anchor industries

Fixing Late Model Ford Focus Engine Vibration Problems

2949 and 3169 Chrysler PT Cruiser Mount Identification

Anchor # 2938, 3003 & 3085

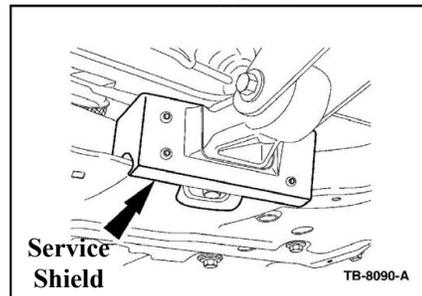
Some 2000-2011 Focus vehicles may exhibit an excessive engine vibration which is most noticeable when the transmission is engaged in reverse. This condition may be caused by small stones, road debris, ice or snow packed/lodged in the rear engine roll restrictor.

Inspect the rear engine roll restrictor for debris and install service shield.

1. Inspect the rear engine roll restrictor for debris.
2. Remove any debris from rear engine roll restrictor.
3. Remove the cross member-to-roll restrictor attachment bolt.
4. Install service shield. 
5. Install roll restrictor attachment bolt and torque to specification.
 - a. 2000-2007 model year vehicles - 47 N.m (35 lb-ft)
 - b. 2008-2011 model year vehicles - 70 N.m (52 lb-ft)
